ADDENDUM NO. 1

PROJECT NAME: NE Soccer & Tennis Complex- General Construction
UNL PROJECT NUMBER: C909P101/ 10186
BID INVITATION NUMBER: 2339-14-7200

CONSULTANT: RDG Planning & Design
ADDRESS: 301 Grand Avenue
Des Moines, IA 50309

DATE OF ISSUANCE: March 27, 2014
DATE OF BID OPENING: Tuesday, April 8, 2014
3:00 PM CT

FRAMING PLAN - OUTDOOR TENNIS
S3.12

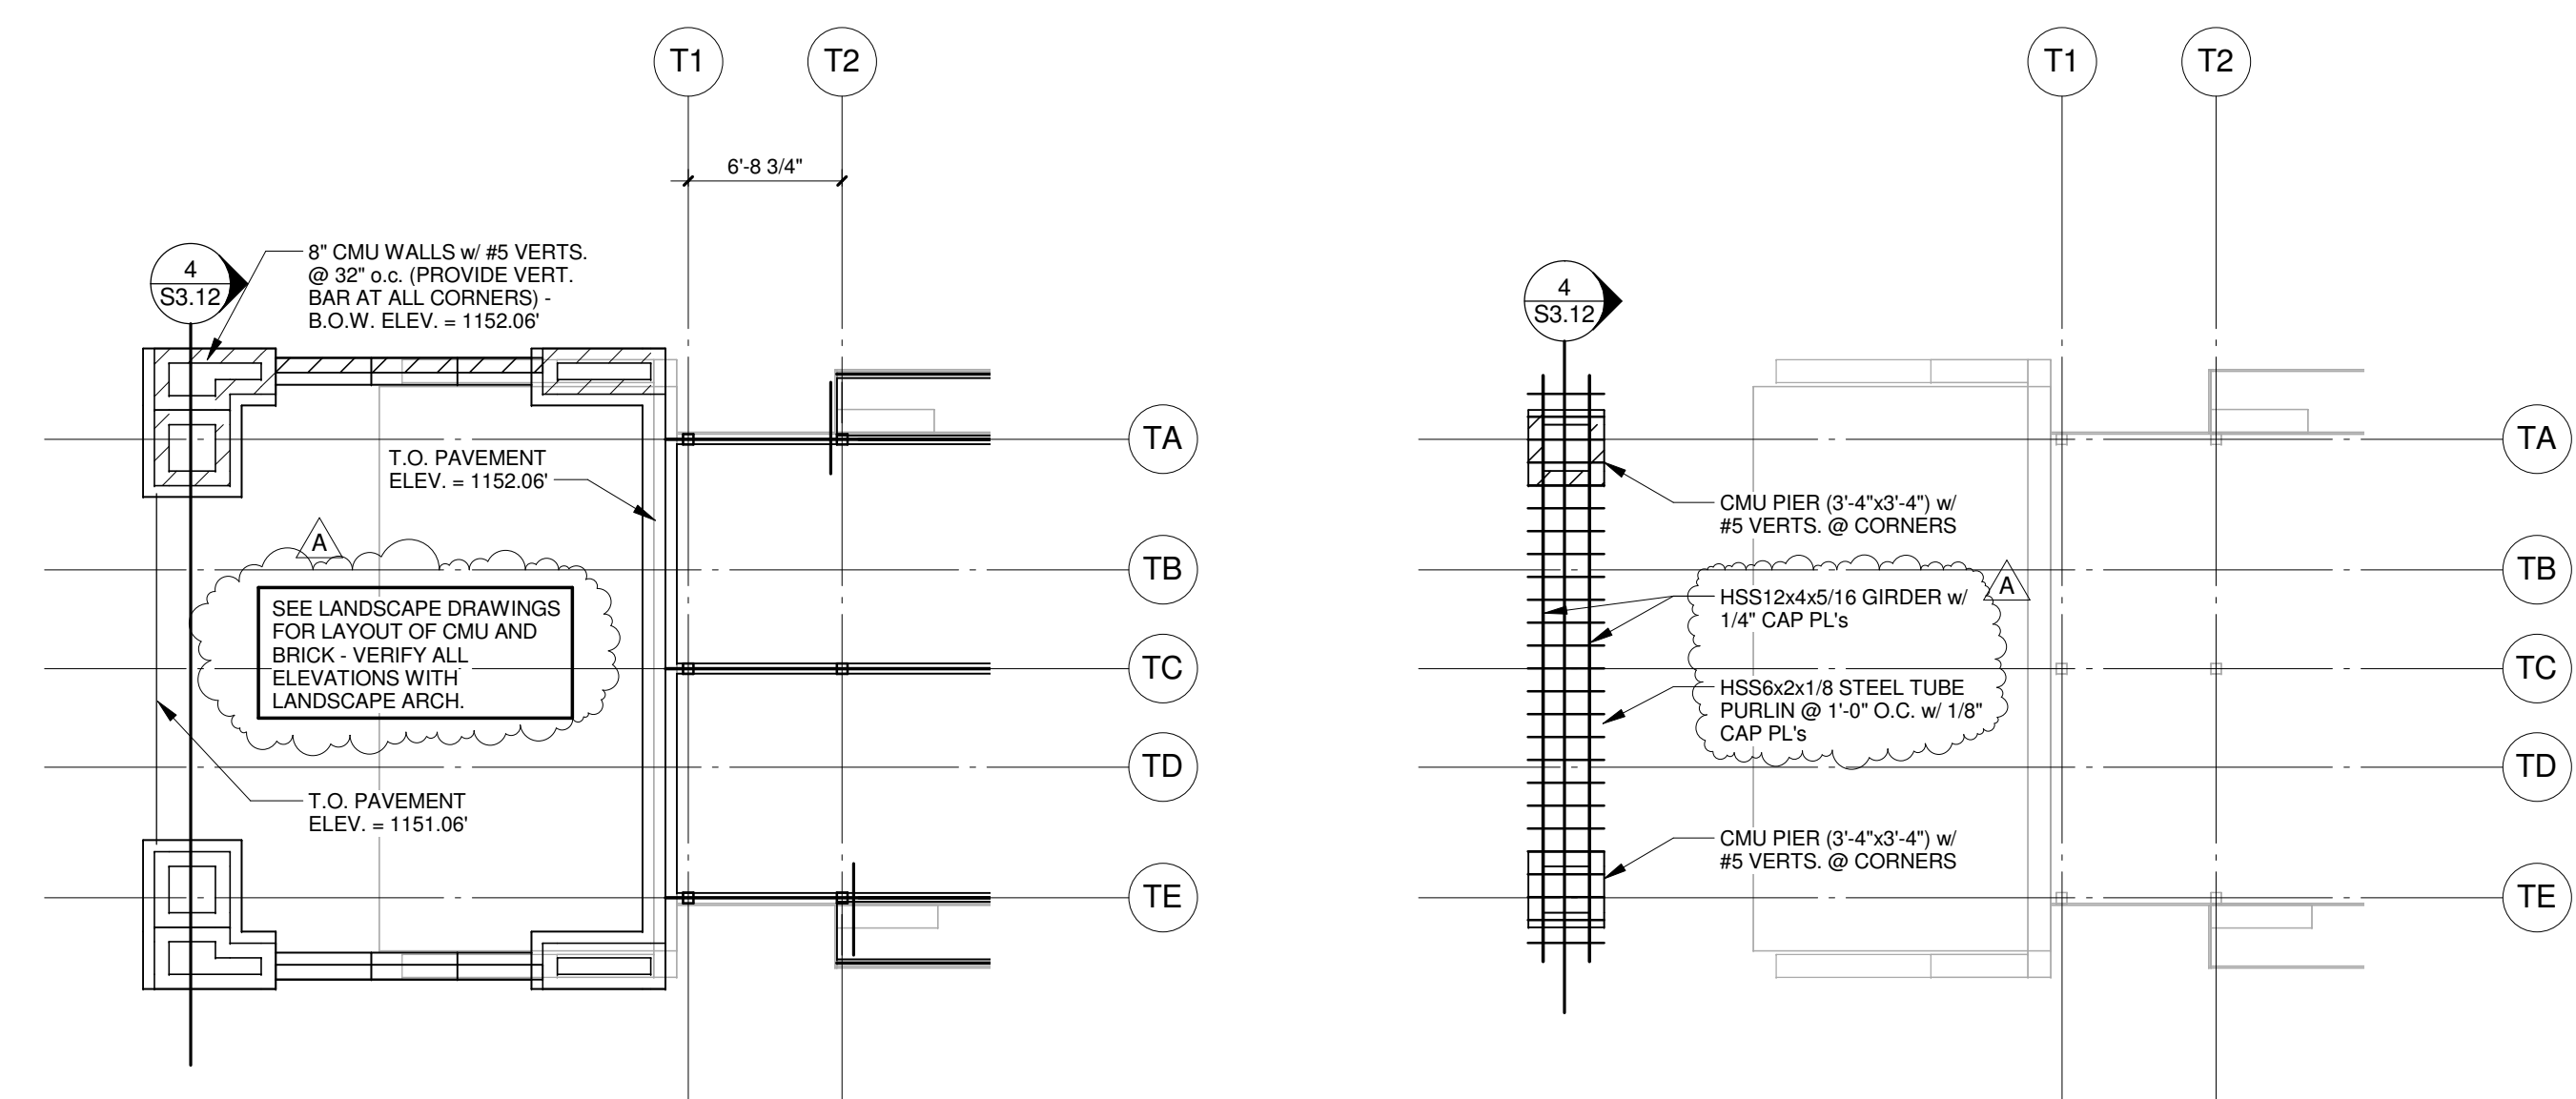
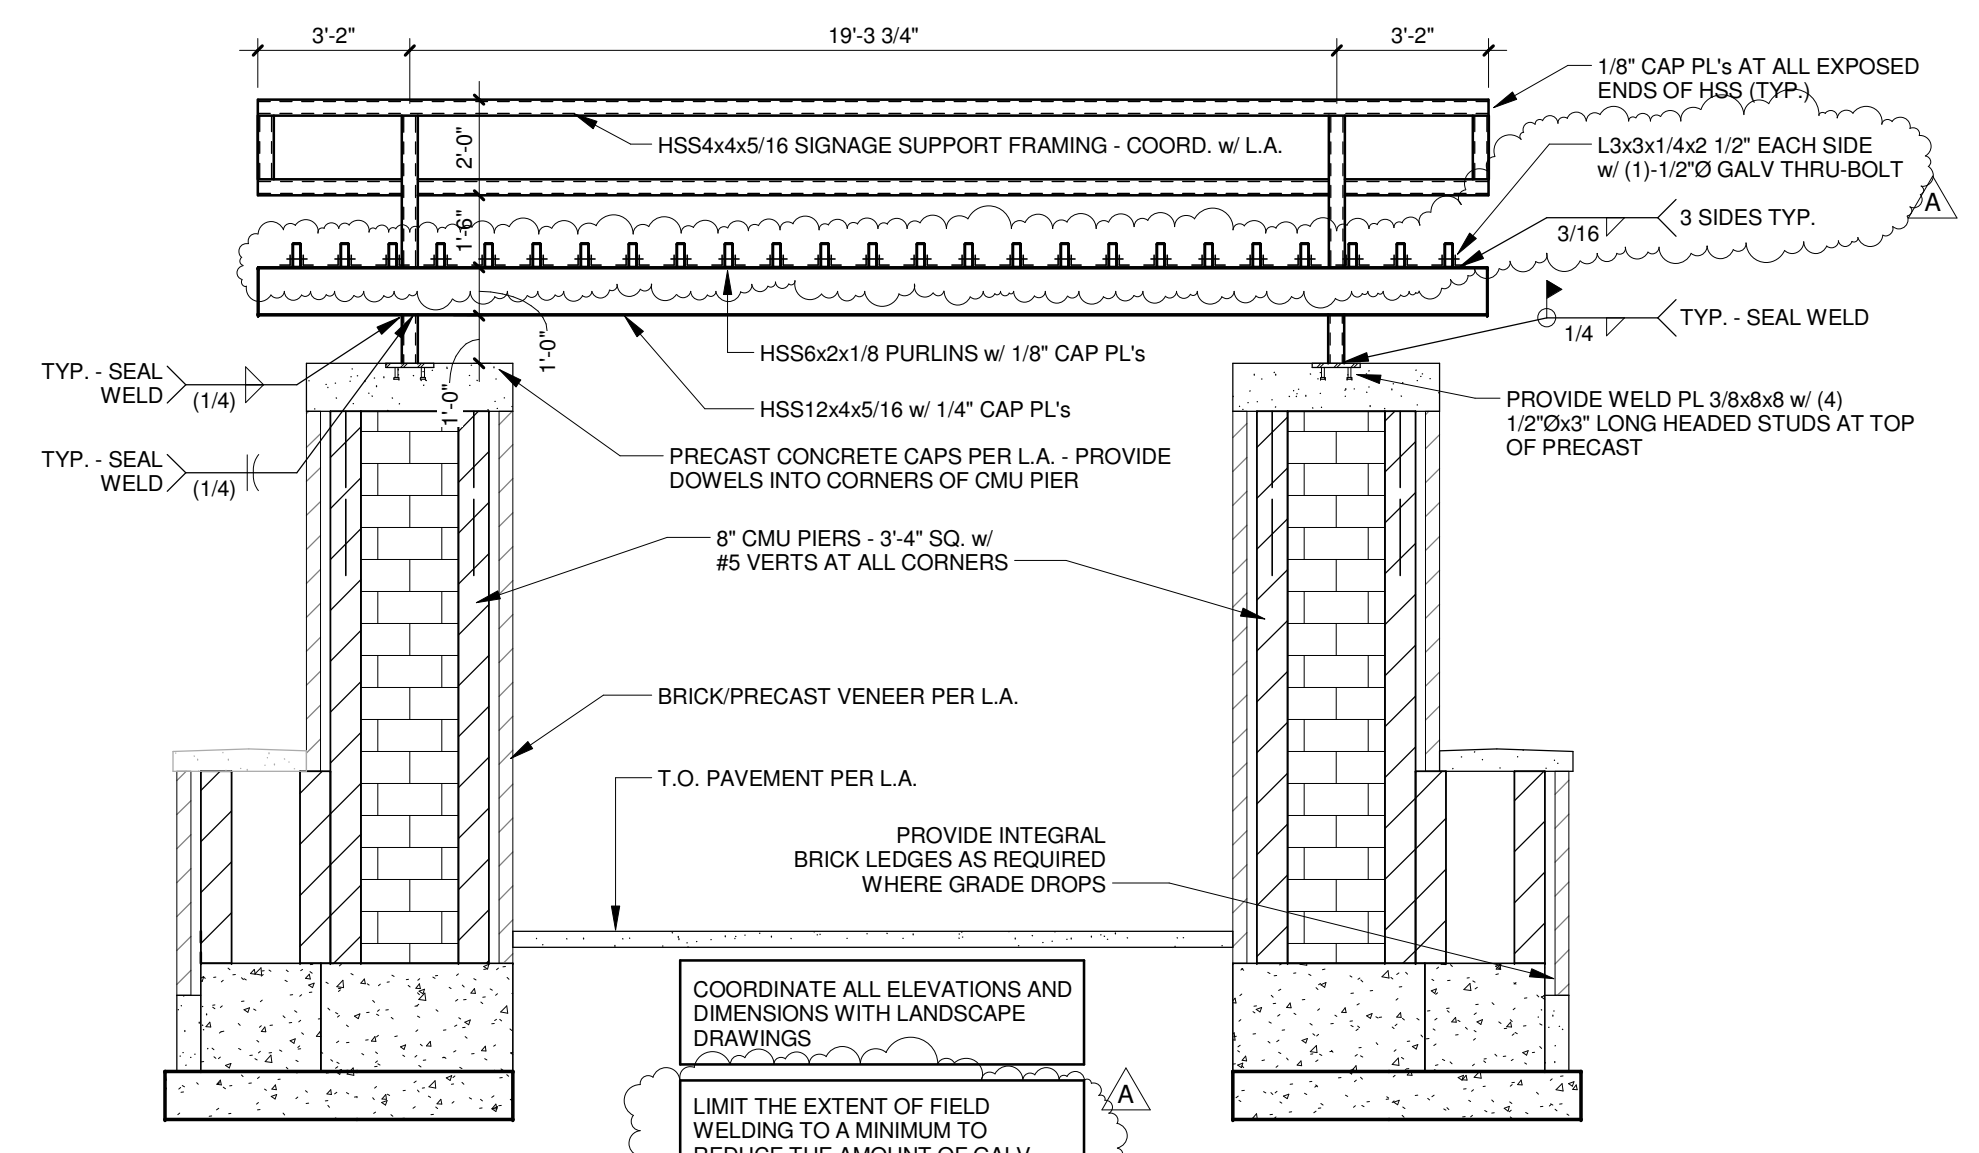
- 1GD-10** DRAWING S3.11 – Foundation Plan – Outdoor Tennis:
- A. Adds note to detail 2 “VERIFY ALL ELEVATIONS WITH LANDSCAPE ARCH.”
- 1GD-11** DRAWING S3.12– Framing Plan – Outdoor Tennis: Revise per attached Drawing S3.12. (Revises steel beam sizes in detail 3 and connection types in detail 4.

3 BUILDING SECTION AT TICKETS

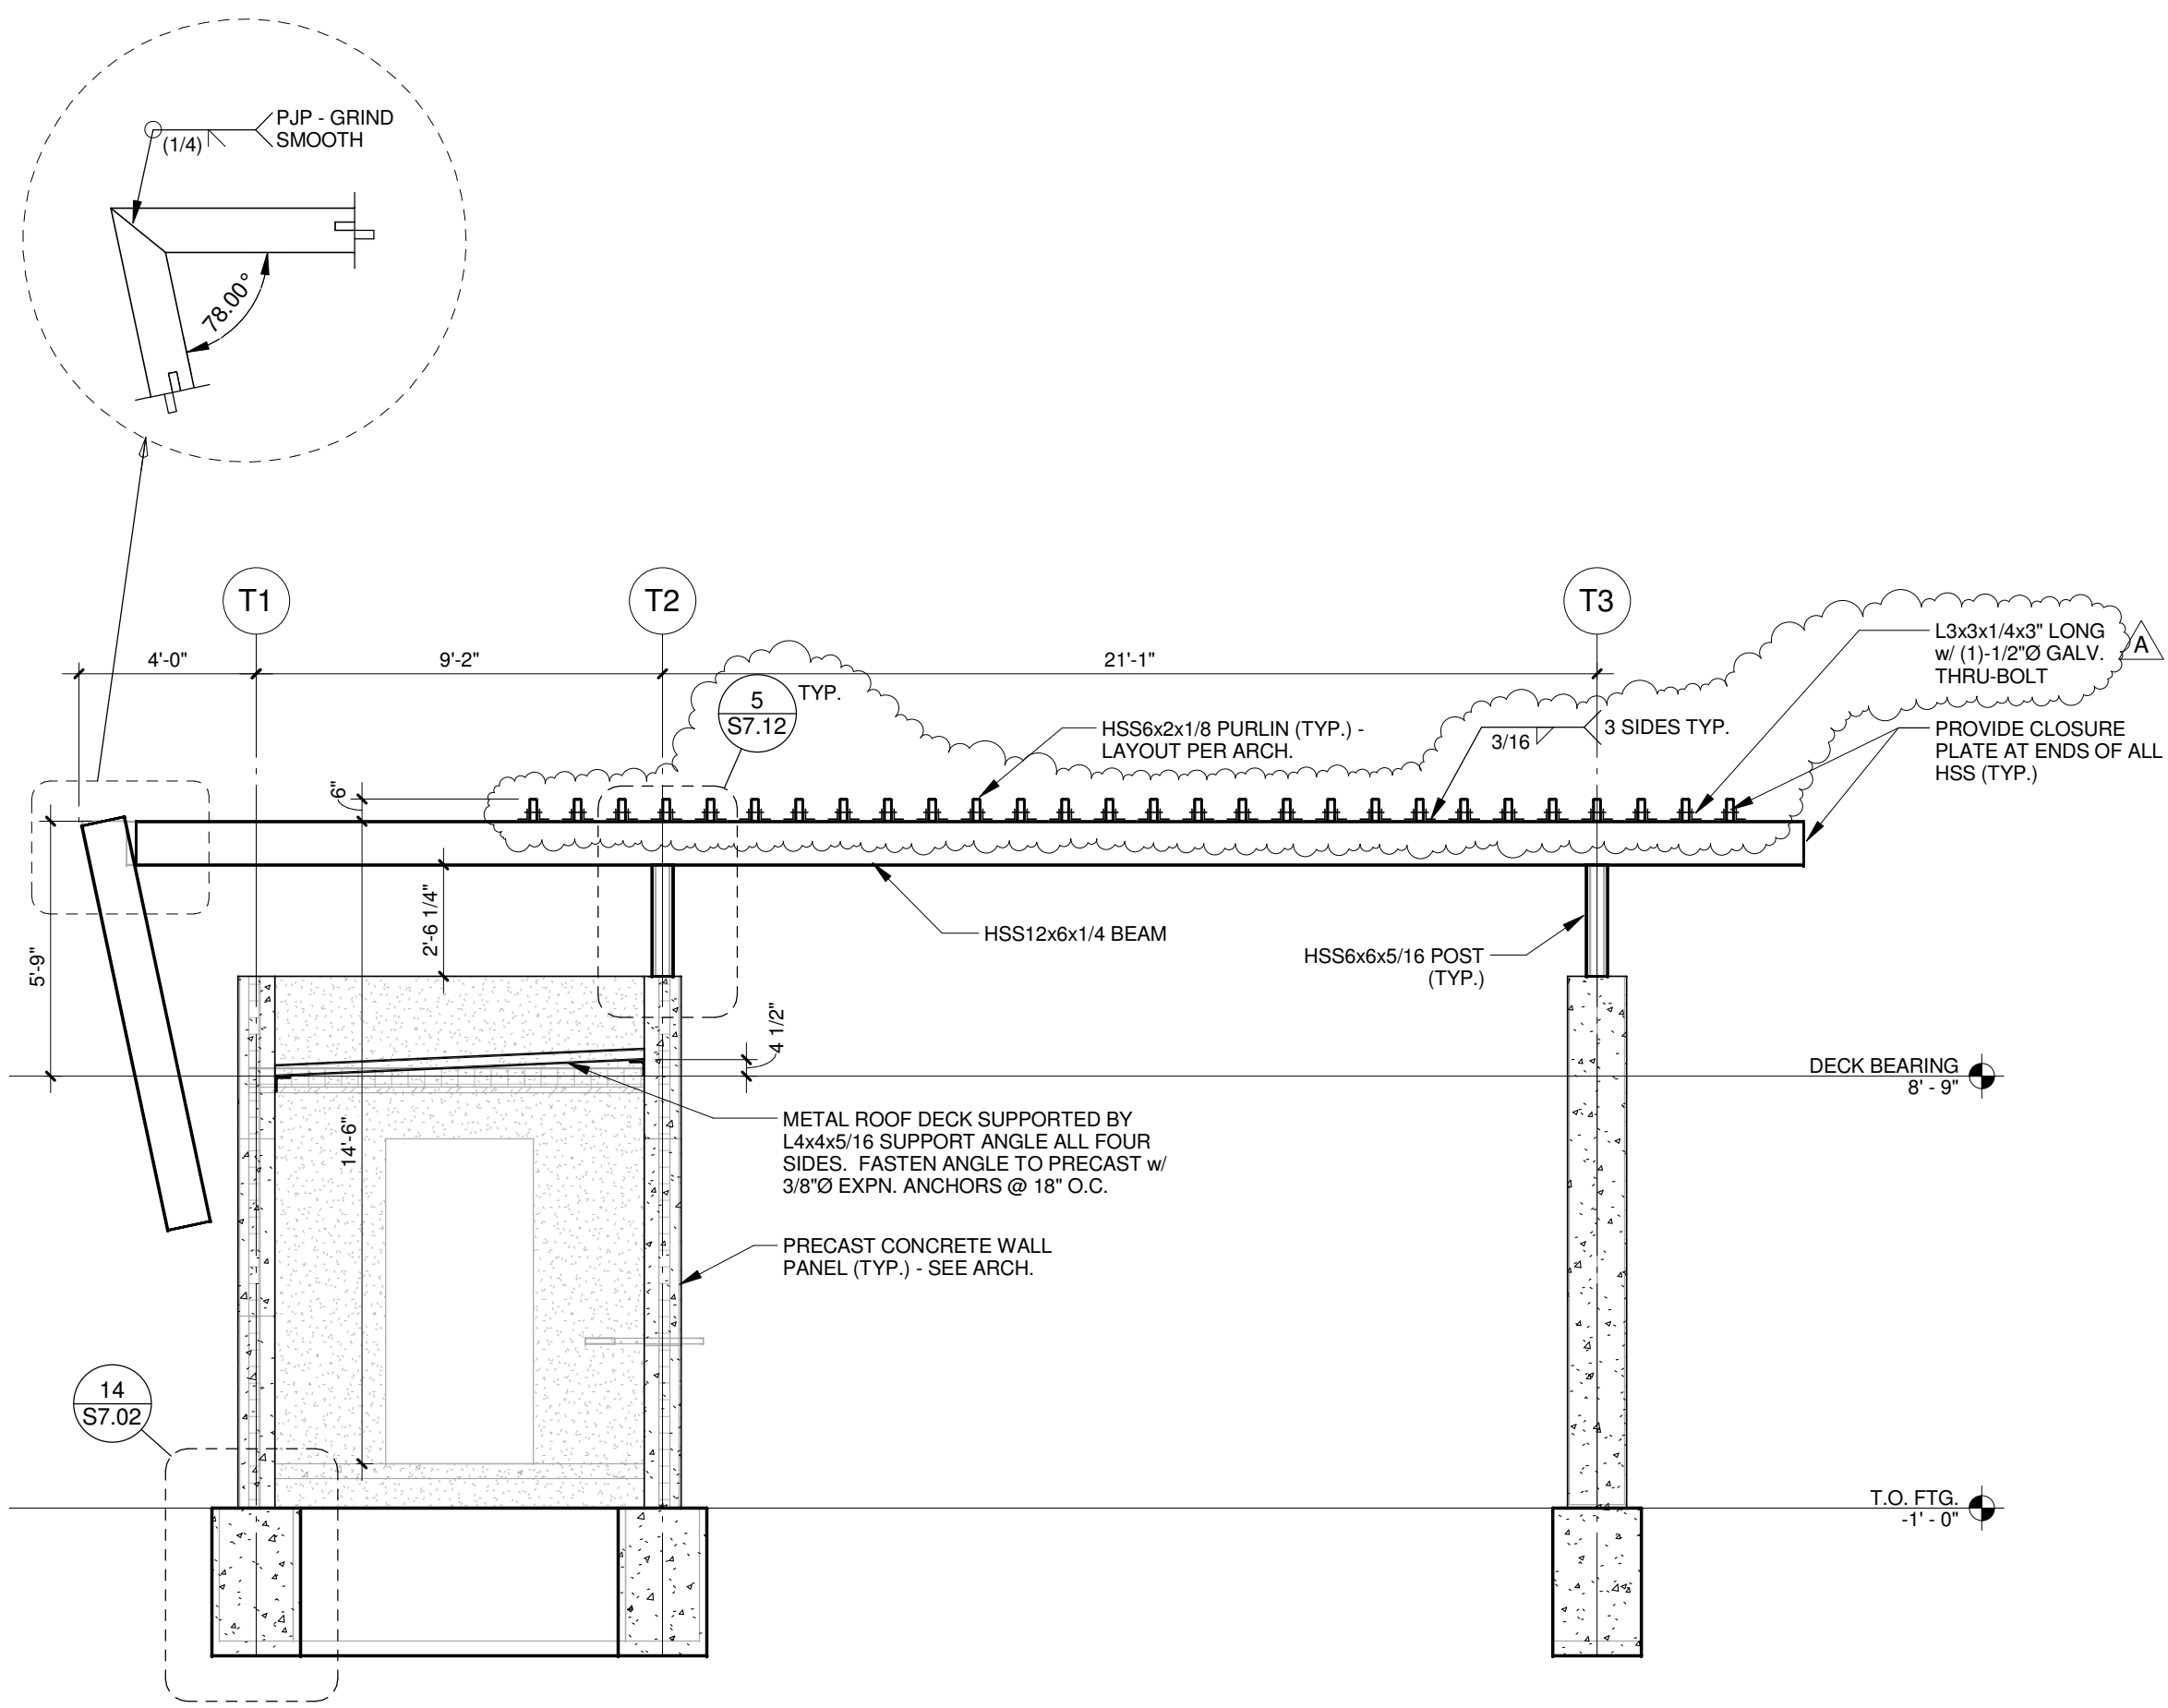
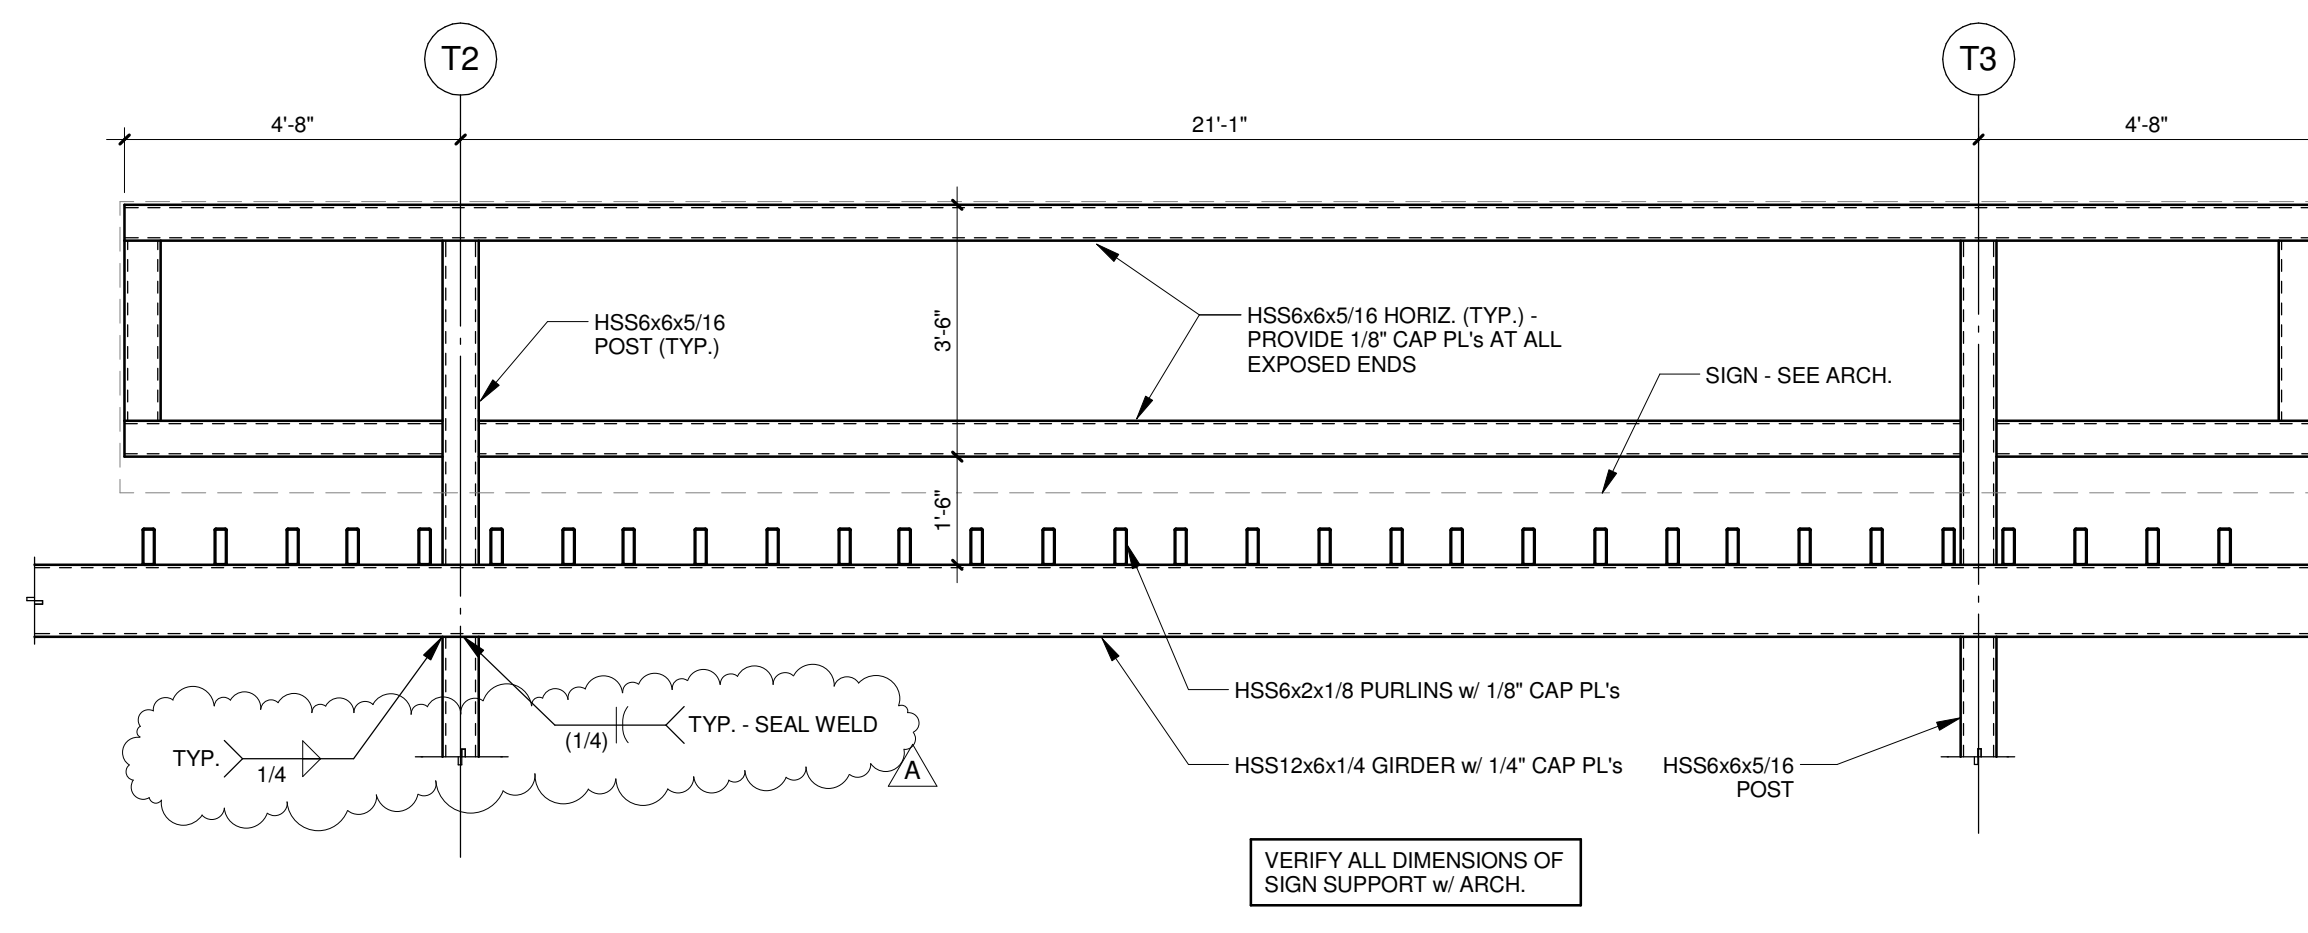
- 1GD-12** DRAWING S4.01– Tickets: Revise per attached Drawing S4.01. (Revises steel beam connections in details 3 and 4).
- 1GD-13** DRAWING S6.01– Structural Schedules:
